ADDENDUM NUMBER 02 TO THE BID DOCUMENTS

**BID DOCUMENT: 17/18 MB7
I21-35617 - Organic Farm Classrooms
College of Marin – Indian Valley Campus**

Addendum Date: 23 February 2018

A1.01

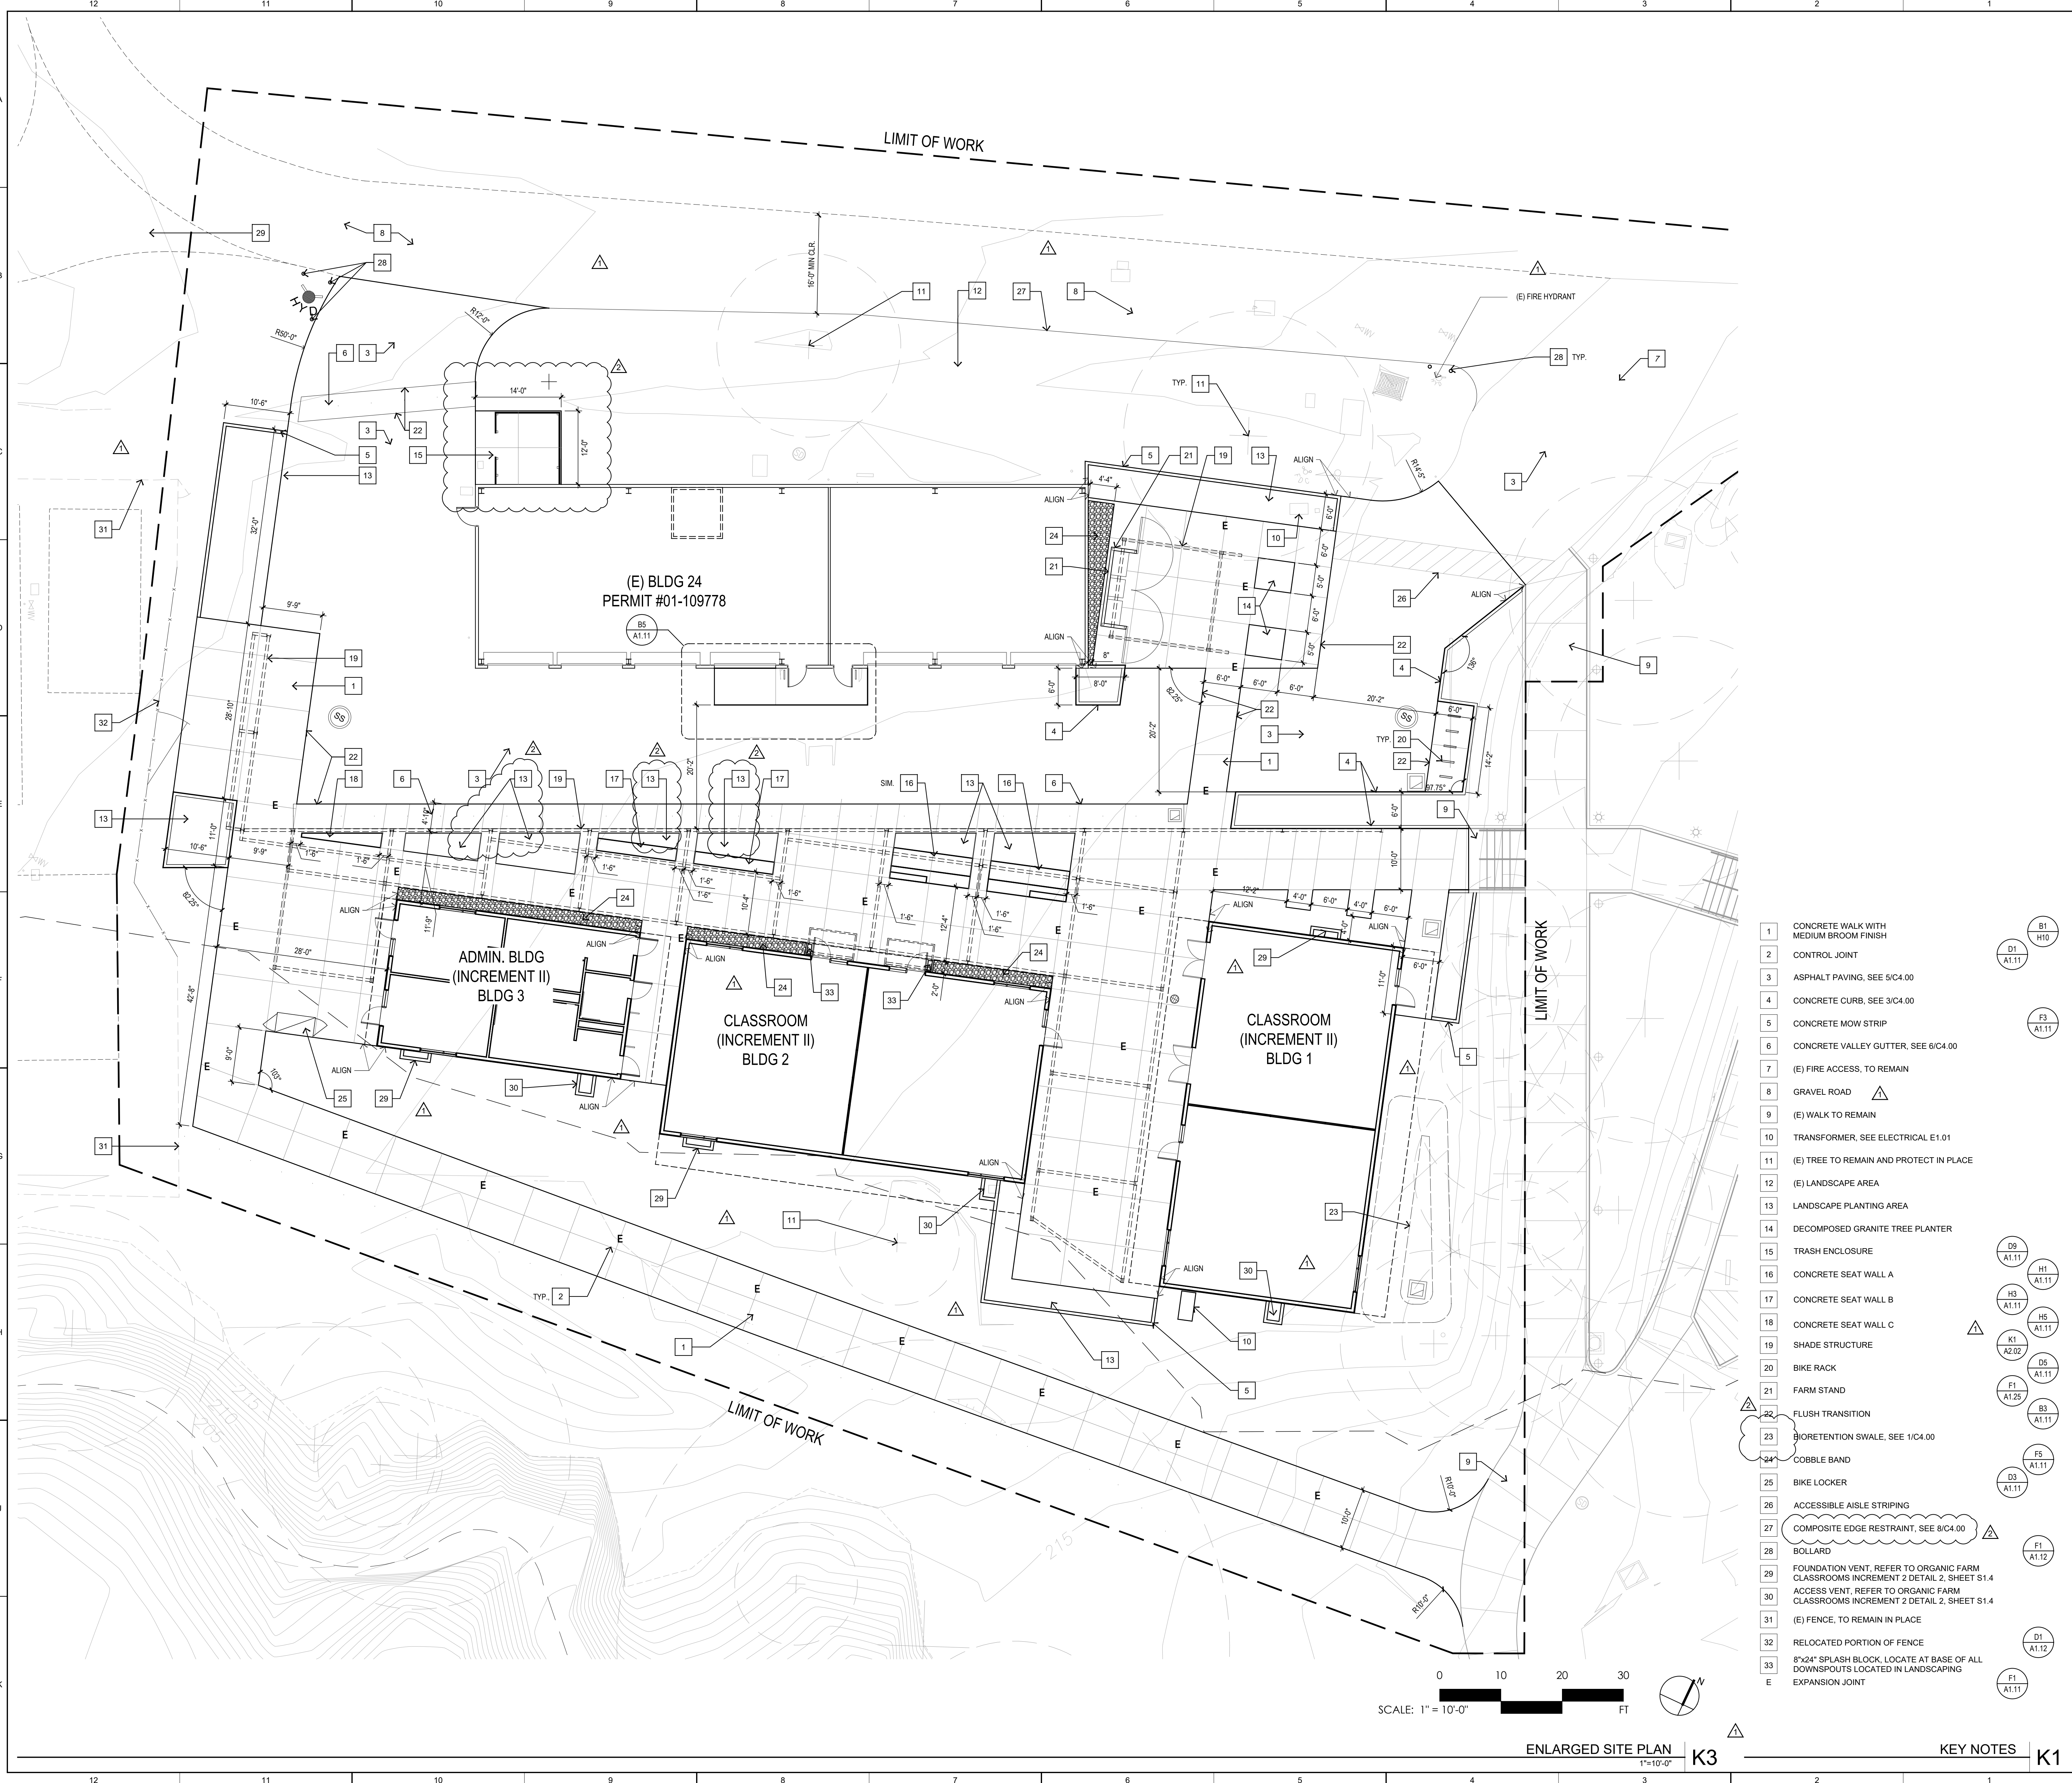
- Revised key note 23, removed one duplicate number.
- Revised key note 27, steel to composite edge restraint.
- Revised trash enclosure.
- Key notes added to show new landscape areas.

A1.11

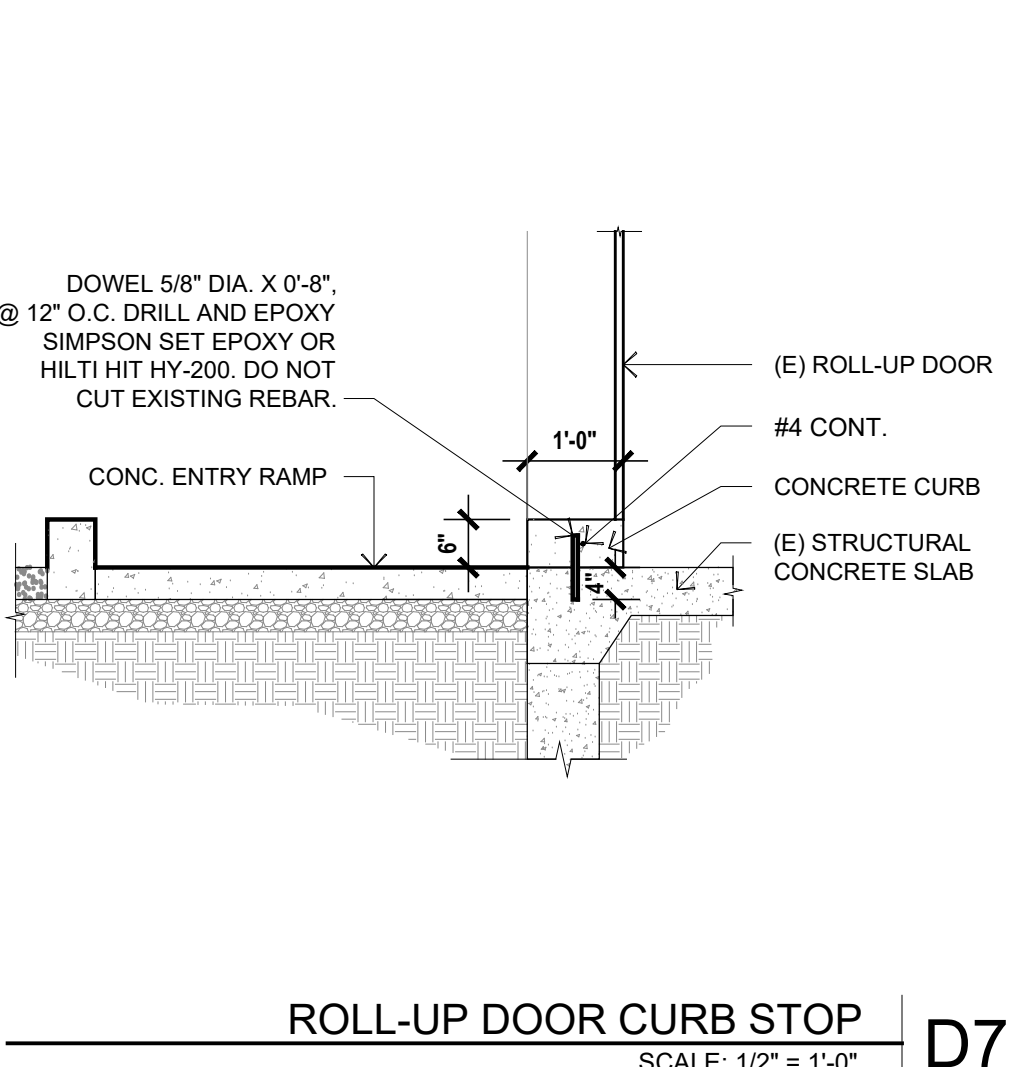
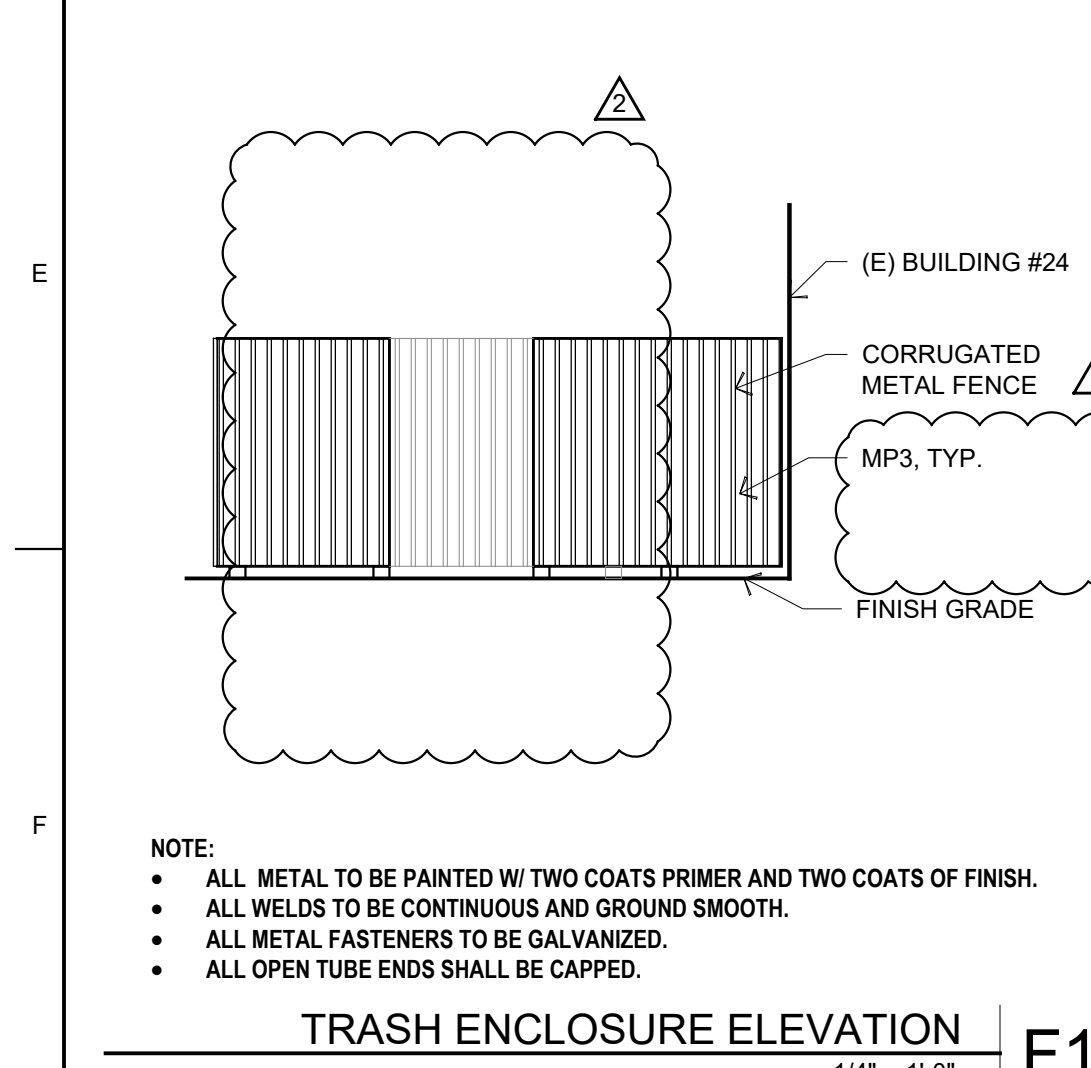
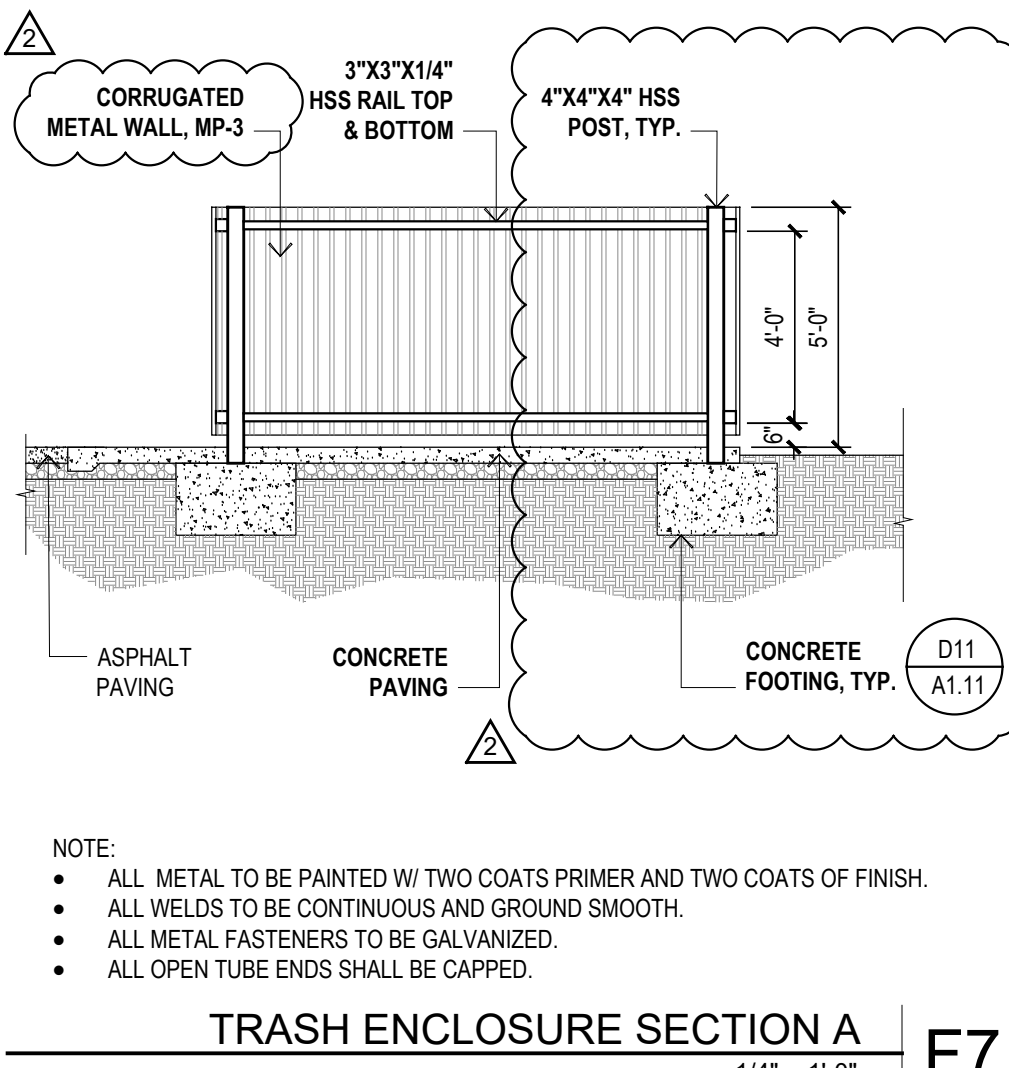
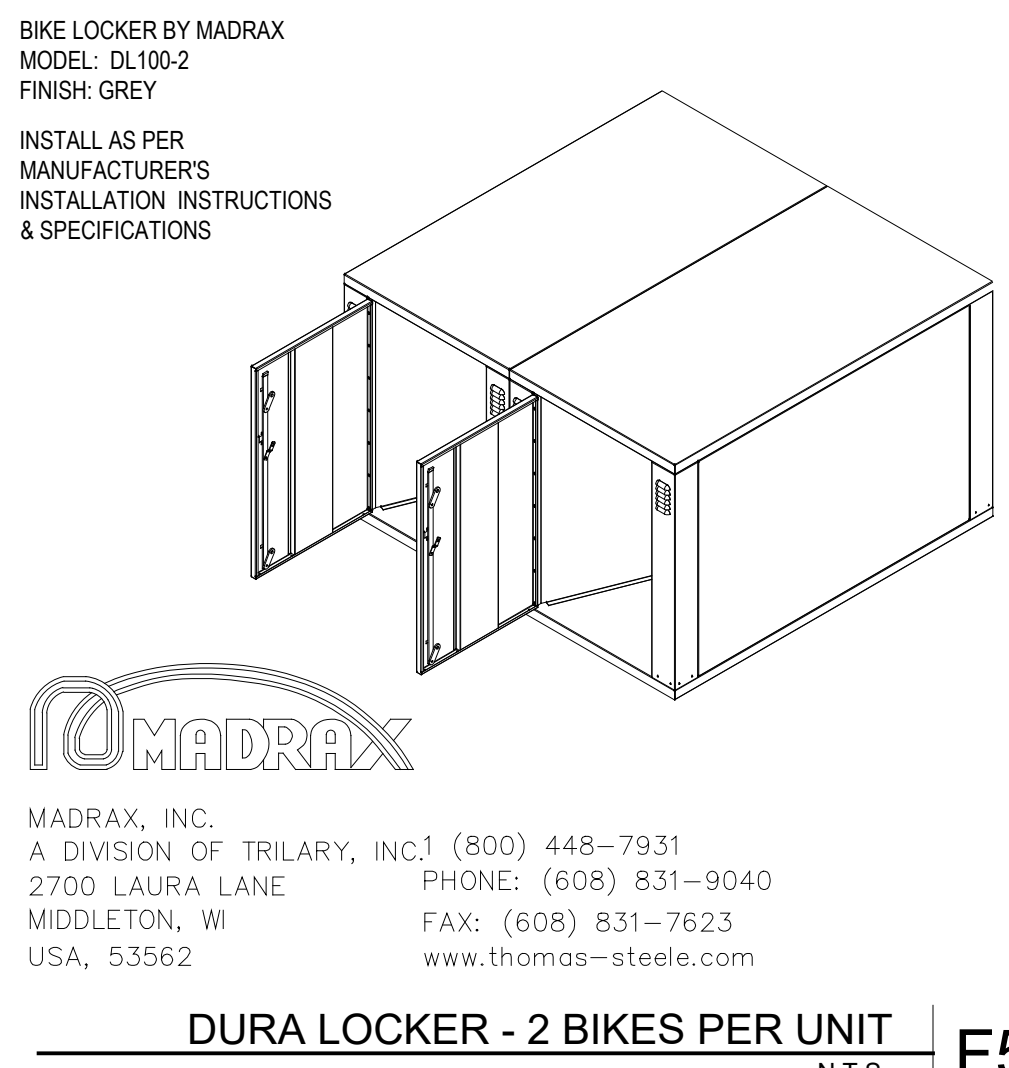
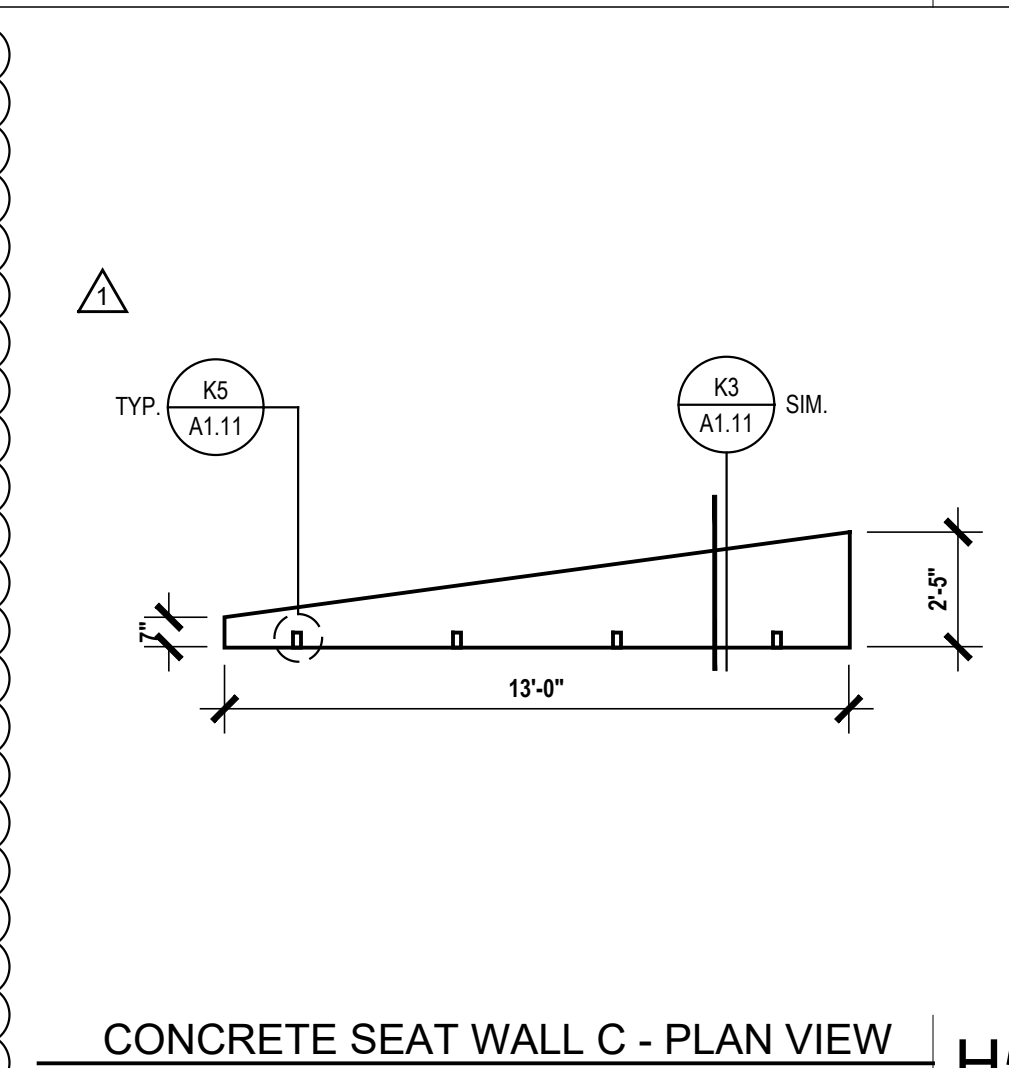
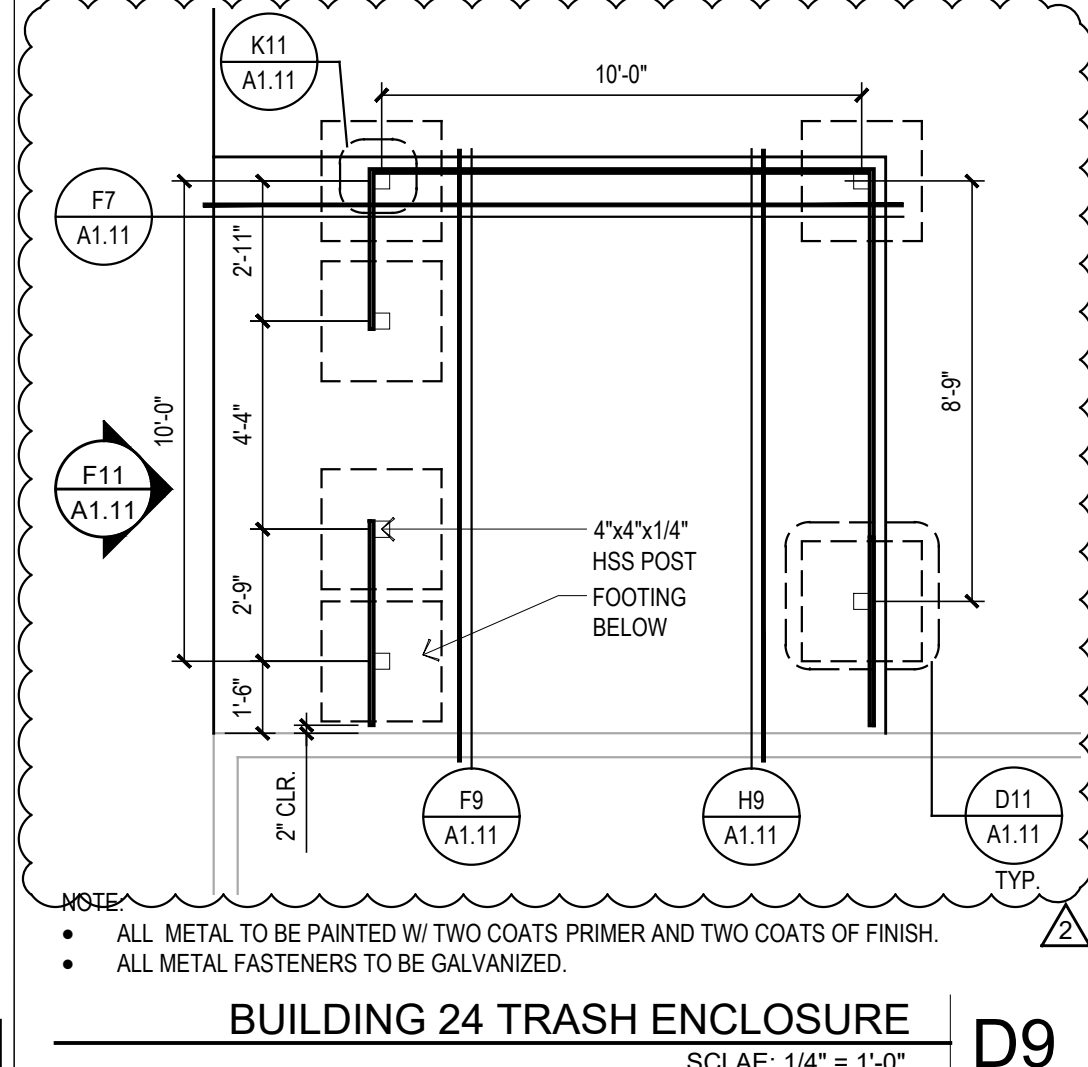
- Revised trash enclosure details.
- Trash enclosure gate details removed.
- Reinstate DSA approved comments.
- Revised concrete detail notes to include mock up.
